SUNDRY NOTICES AND REPORTS ON WELLS

San Juan 32-8 Unit #260A

ConocoPhillips requests to move the location of this well and drill as a directional wellbore as per the attached revised supporting documents.

WELL LOCATION AND ACREAGE DEDICATION PLAT

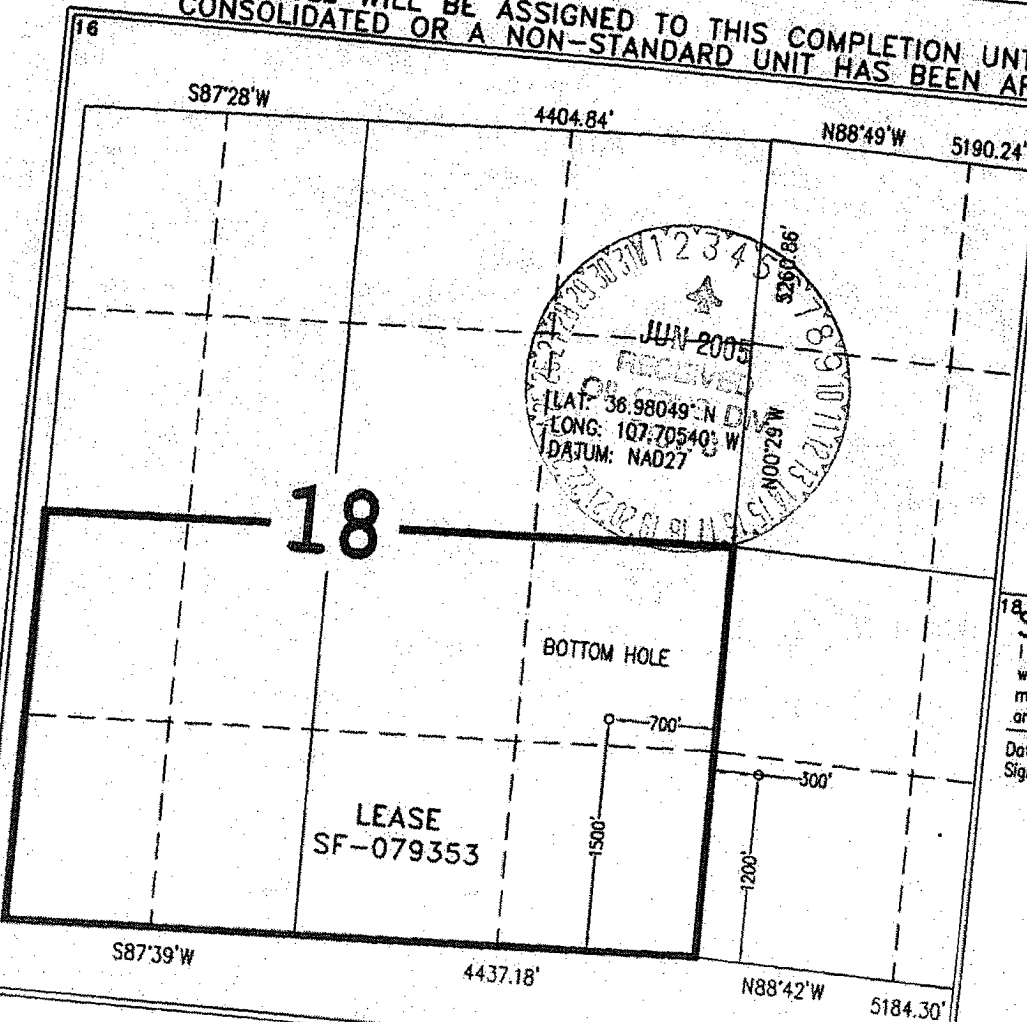
The new location of this well will be:

Surface: SWSW 1200 FSL - 300 FWL Section 17, T32N, R8W, NMPM
Bottom Hole: NESE 1500 FSL - 700 FEL, Section 18, T32N, R8W, NMPM
